Colorado Department of Transportation

NORTH POND AND DITCH DETAIL			
Designer:	SPC	Structure	
Detailer:	JND	Numbers	
Sheet Subset:	Drainage	Subset Sheets:	2 of 4

Project No./Code
ES5 160A-010
17269
Sheet Number 24

DRAINAGE STRUCTURE SECTIONS
 Designer: sc
 Detailer: mn
 Sheet Subset: Drainage
 Subset Sheets: 4 of 4

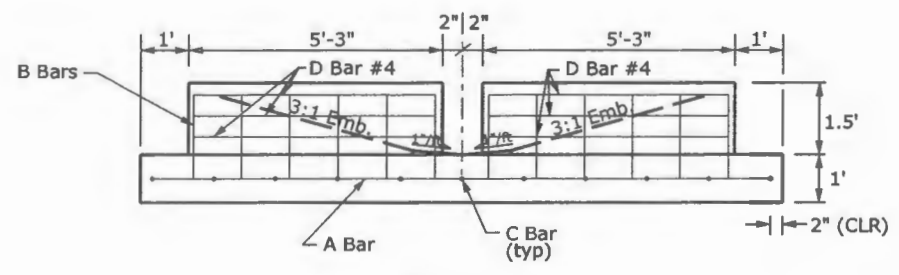
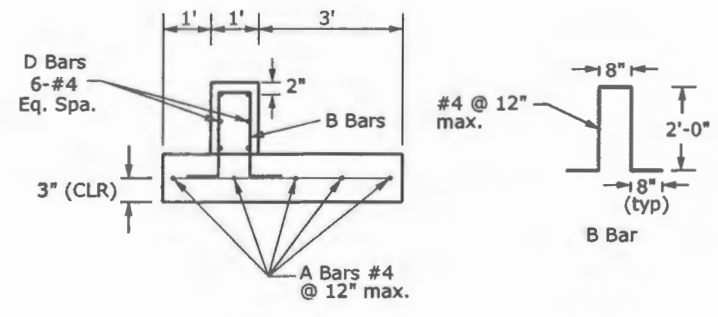
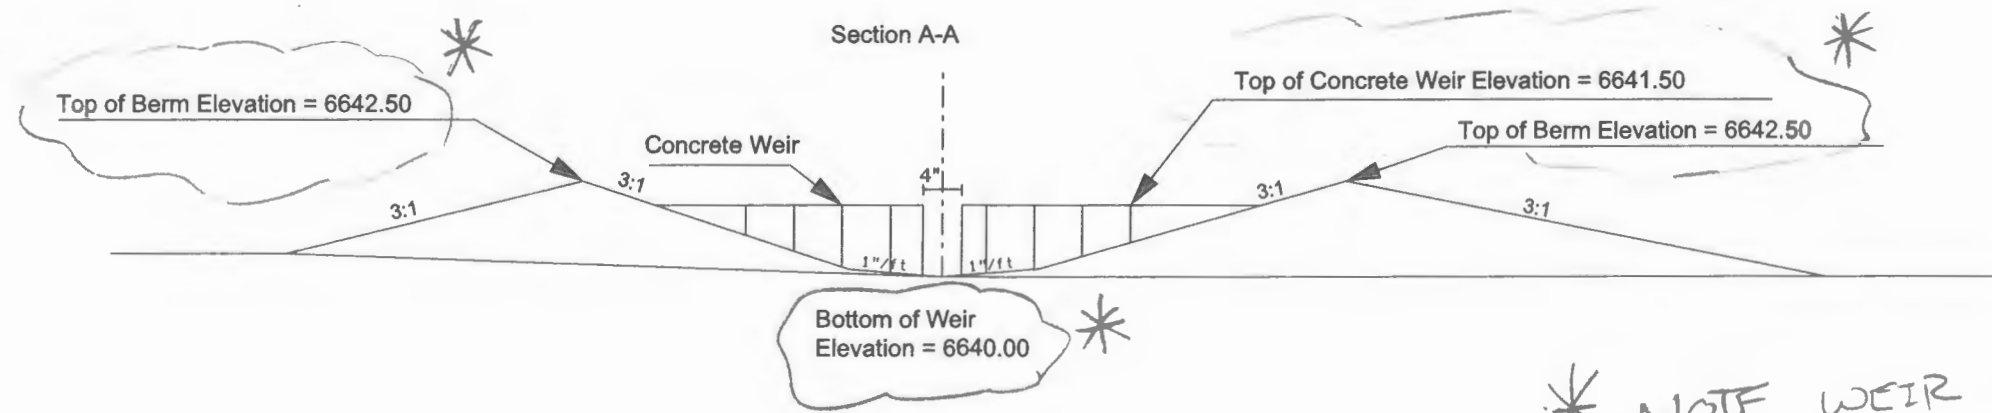
Sheet Revisions		
Date:	Comments	Init.
07/01/09	Class A to Class 2	EJA

* NOTE WEIR LOCATION ADJUSTED 7' = EL

STATION 401+15
 Required: 24" X 56' RCP with
 Type C Inlet Rt.
 Top of Grate EL = 6697.08
 D.A. = 3.0 acres
 Q100 = 11.13 cfs
 DHW = 6697.40 ft
 AHW = 6698.43 ft

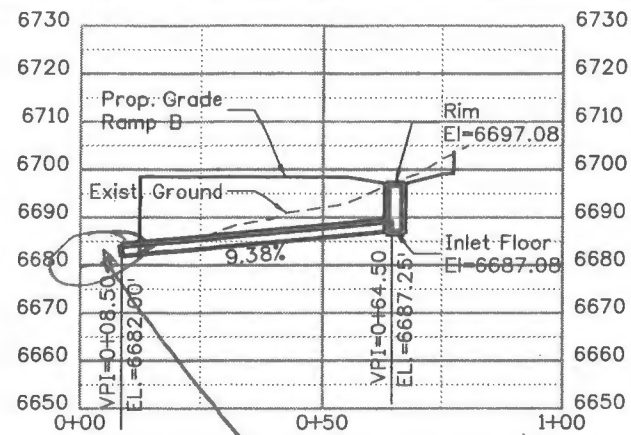
*OUTLET PROTECTION
 ADDED PER 105-AB*

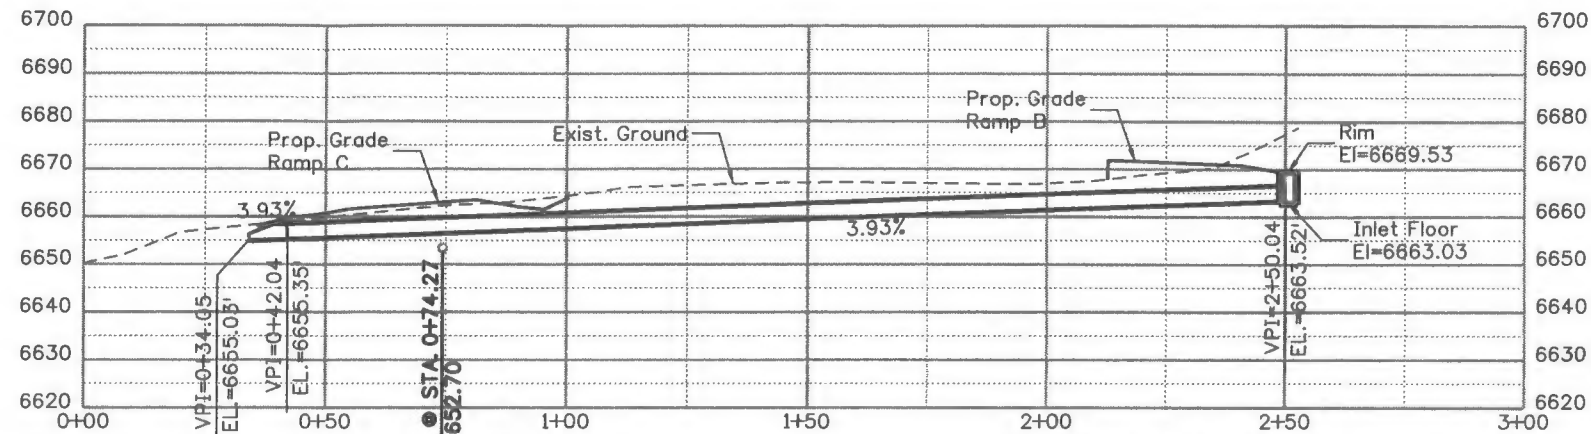
*CONCRETE PAVERS
 ADDED MOUND OUTLET
 FOR EROSION CONTROL*

STATION 407+55.90
 Required: 36" X 208' RCP with
 Type D Inlet Rt. and F.E.S. Lt.
 Top of Grate EL = 6669.53
 D.A. = 13.5 acres
 Q100 = 45.64 cfs
 DHW = 6670.77 ft
 AHW = 6670.87 ft

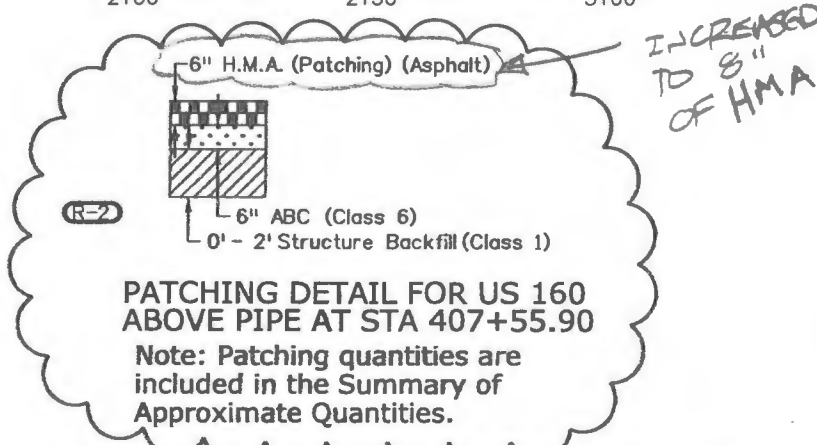
INCREASED TO 8" OF HMA

STATION 404+16 Rt.
 Required: 24" X 72' RCP with
 Type D Inlet Rt. and
 FES Lt.
 Top of Grate EL = 6680.00
 D.A. = 7.5 acres
 Q100 = 25.23 cfs
 DHW = 6680.37 ft
 AHW = 6680.92 ft

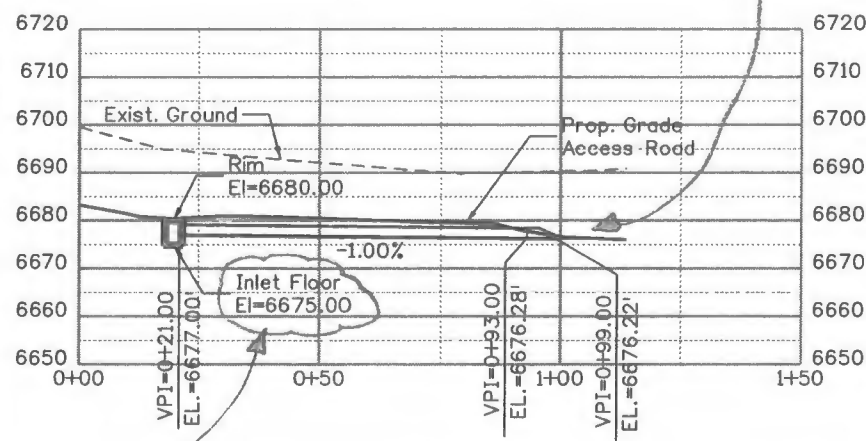
*BOTTOM OF INLET
 RAISED IN FIELD*

RIGHT OF WAY FENCE			
Designer:	SPC	Structure Numbers	
Detailer:	JND		
Sheet Subset:	Fencing	Subset Sheets:	1 of 2

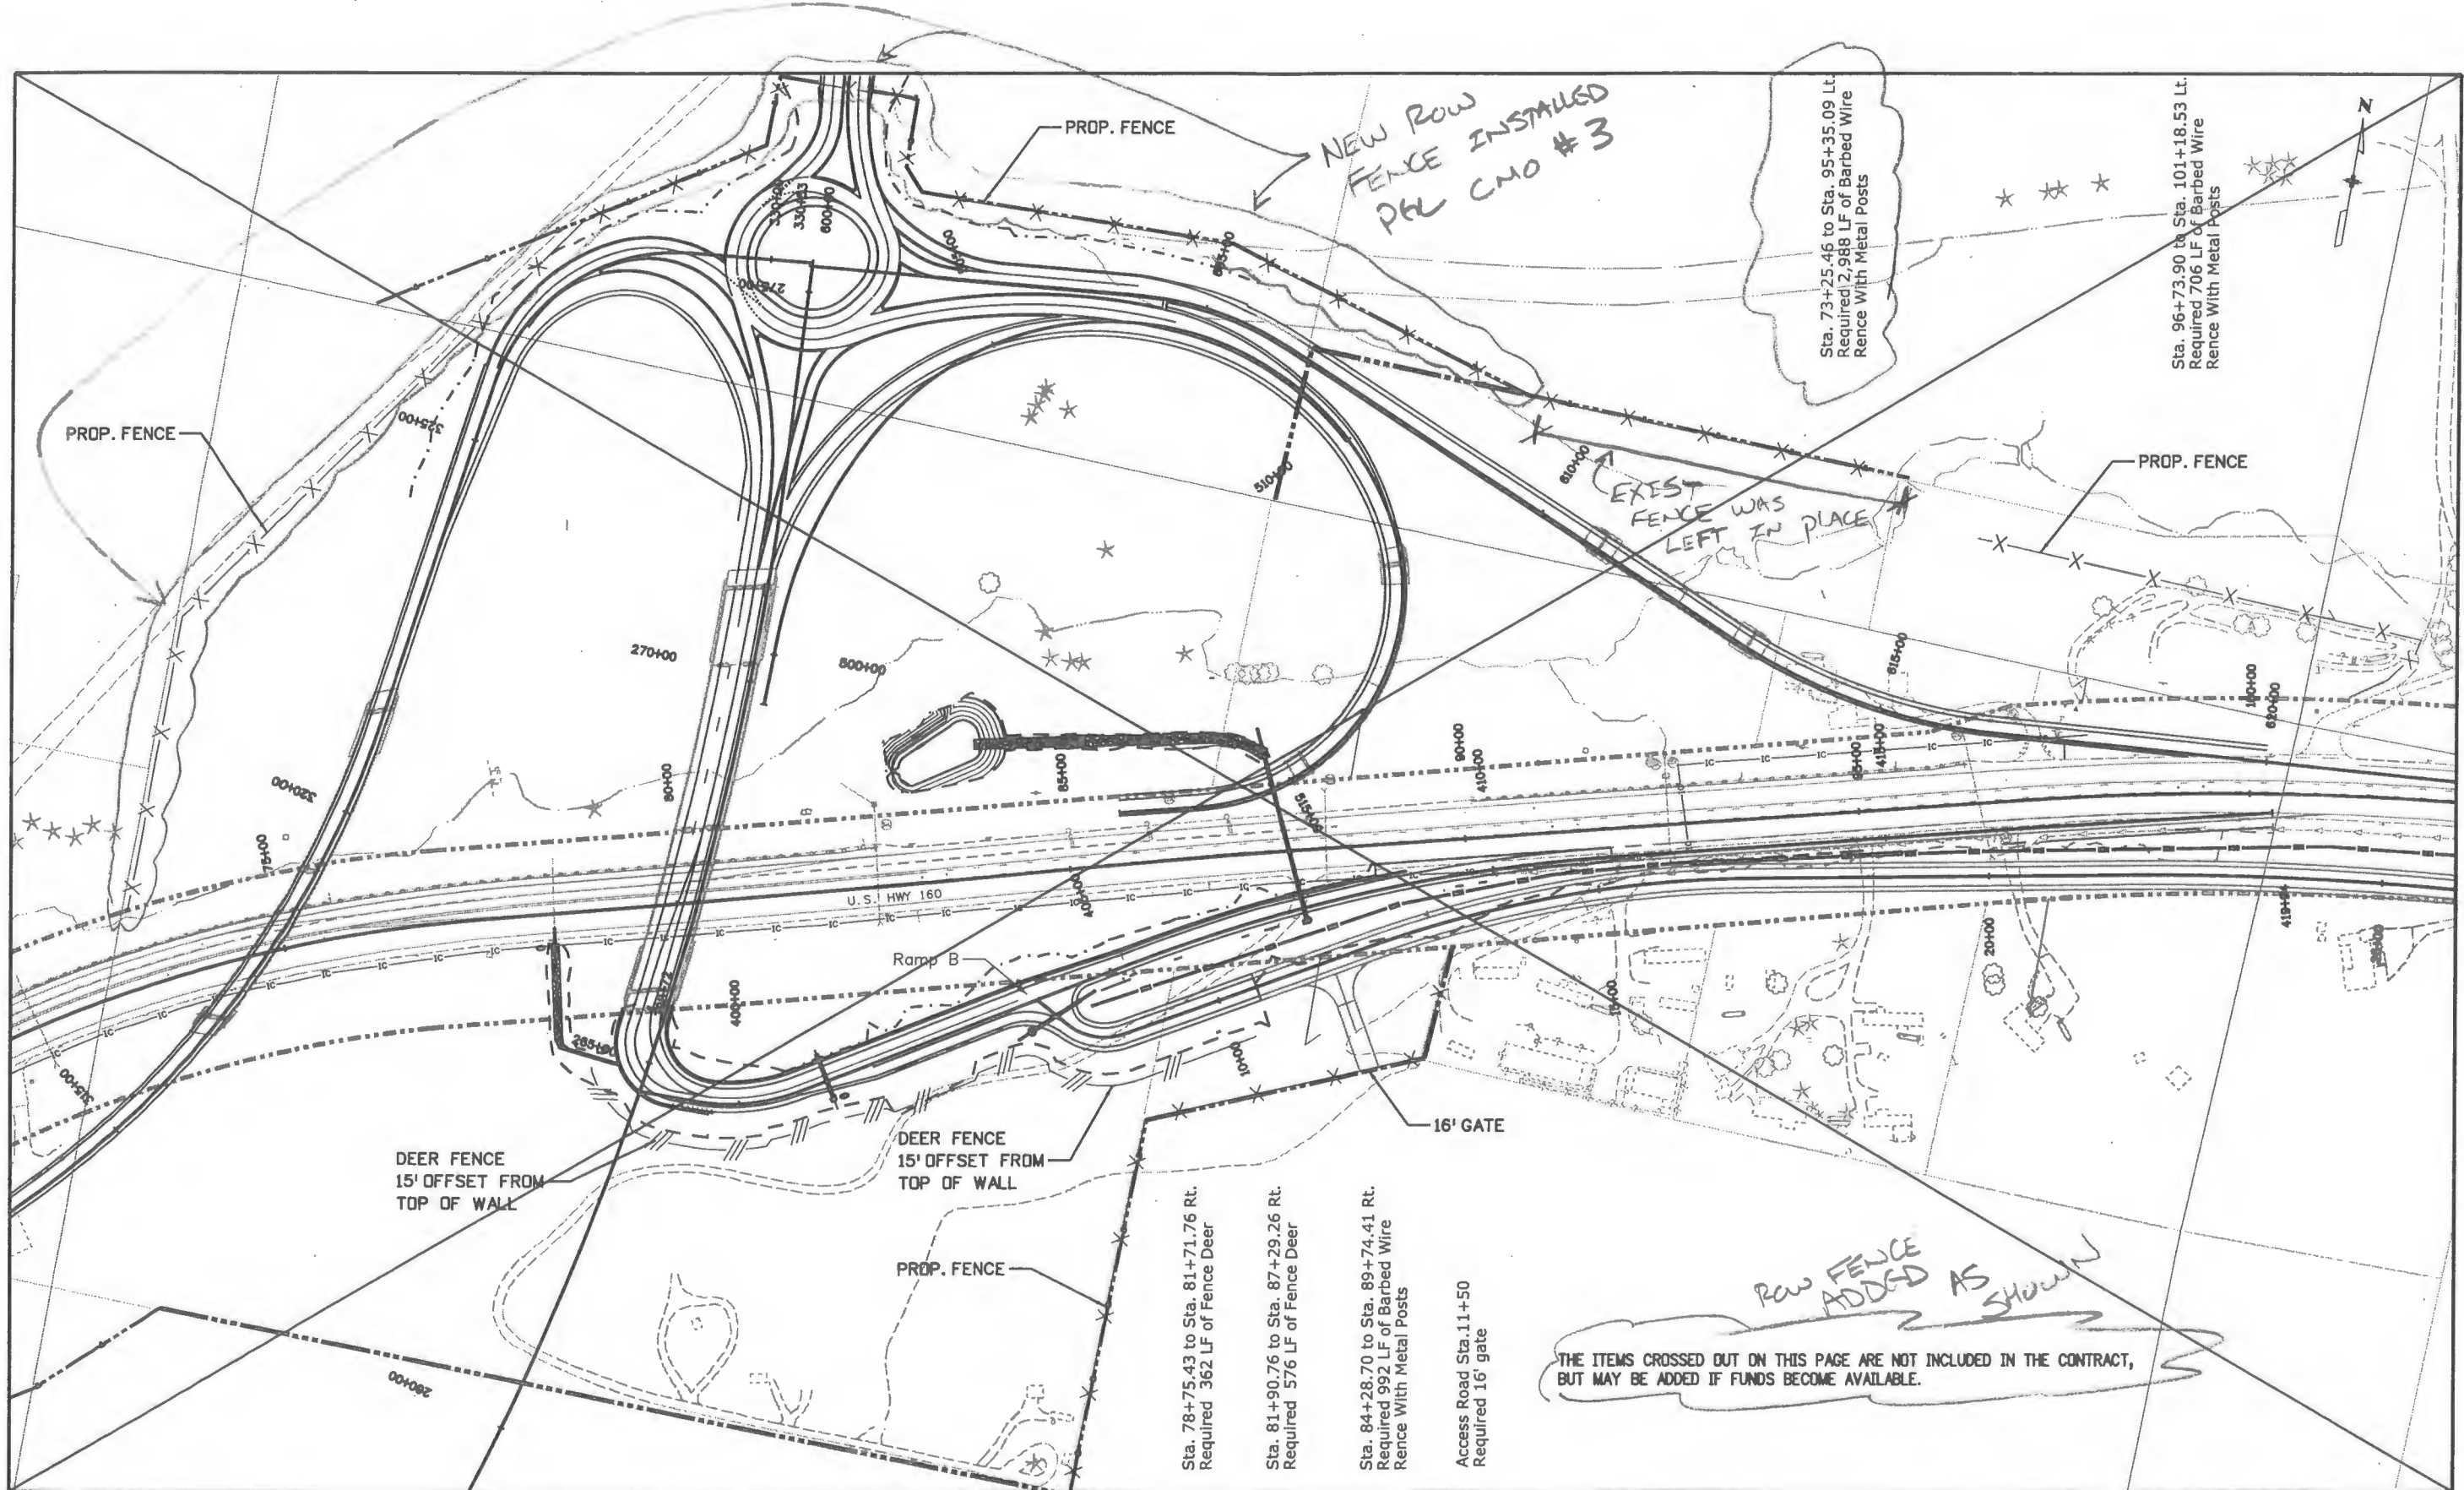
*ROW FENCE
ADDED AS NOTED
ON NEXT SHEET
PER CMO #3*

* Access Road Sta. 11+50 Rt. Install a 16' Gate. See next sheet
